# Providence City Plan Commission

## AGENDA ITEM ■ 220 BLACKSTONE STREET

<b>OWNER/ APPLICANT:</b>	Marathon Development LLC	<b>PROJECT DESCRIPTION:</b>	Major change to an approved plan to increase the height of a building from two stories to five stories, a change of over 20% from what was approved.
<b>CASE NO./ PROJECT TYPE:</b>	25-006 MA Major Change		
<b>PROJECT LOCATION:</b>	220 Blackstone Street M-MU 75 AP 45 Lot 85	<b>RECOMMENDATION:</b>	Approval of the change subject to the noted findings
<b>NEIGHBORHOOD:</b>	Upper South Providence	<b>PROJECT PLANNER:</b>	Choyon Manjrekar

Proposed site plan

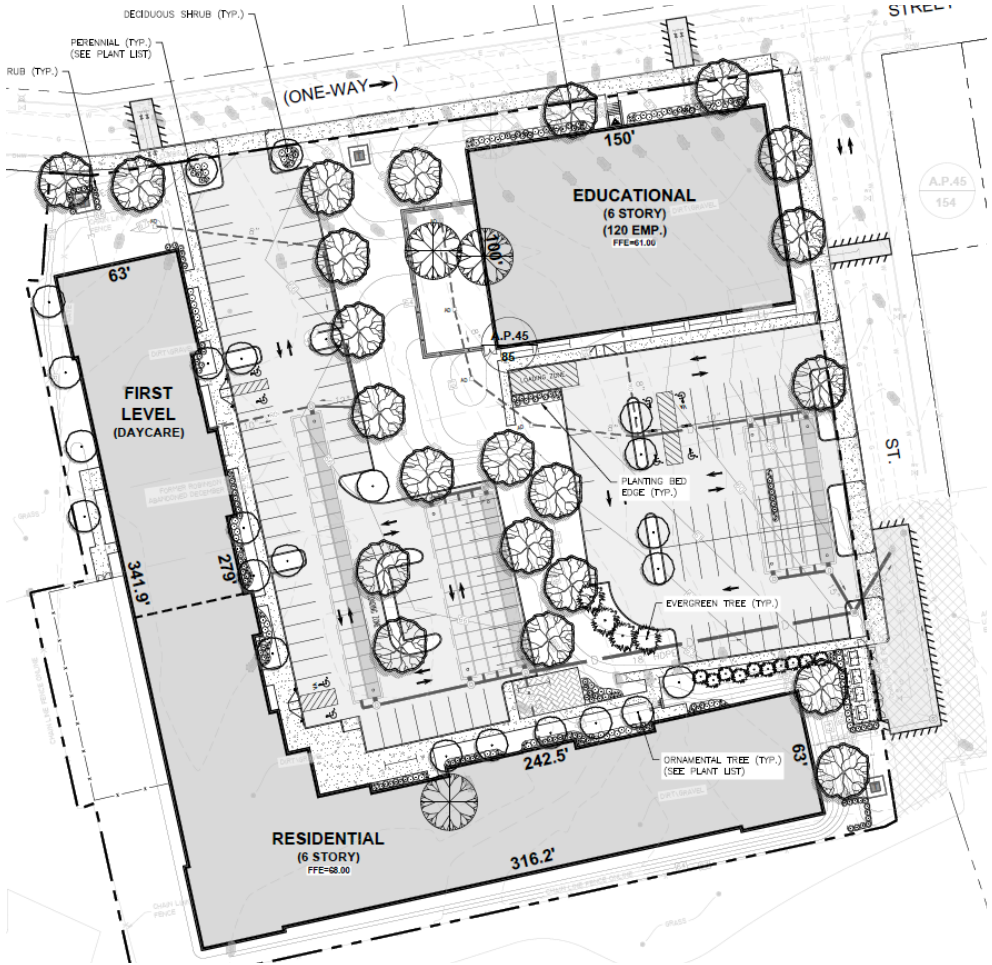
The development requires a total of 228 parking spaces, with 178 required for 178 residential units, 10 for the daycare calculated as 1 space per 1,000 SF and 40 for the school with a requirement of one per 3 employees with 120 employees expected. A total of 126 bicycle parking spaces are required and 63 will be provided. The CPC granted a 50% dimensional adjustment for parking at the preliminary plan stage. The applicant will provide a total of 118 spaces for the development with 66 for the mixed use building and 52 for the school, which is within the limit of the adjustment.

The applicants expects vehicles to access the school parking lot from Gay Street by turning onto Willard Ave from Eddy Street, and exiting onto Blackstone Street. Buses are expected to park on Blackstone Street which is a one way during pickup and drop off times. The applicant will present additional information on the traffic pattern to the CPC. The traffic plan shall be subject to the City Engineer's review.

1. The drainage plan shall be subject to the City Engineer's approval
2. Processing of the final plan should be delegated to DPD staff.
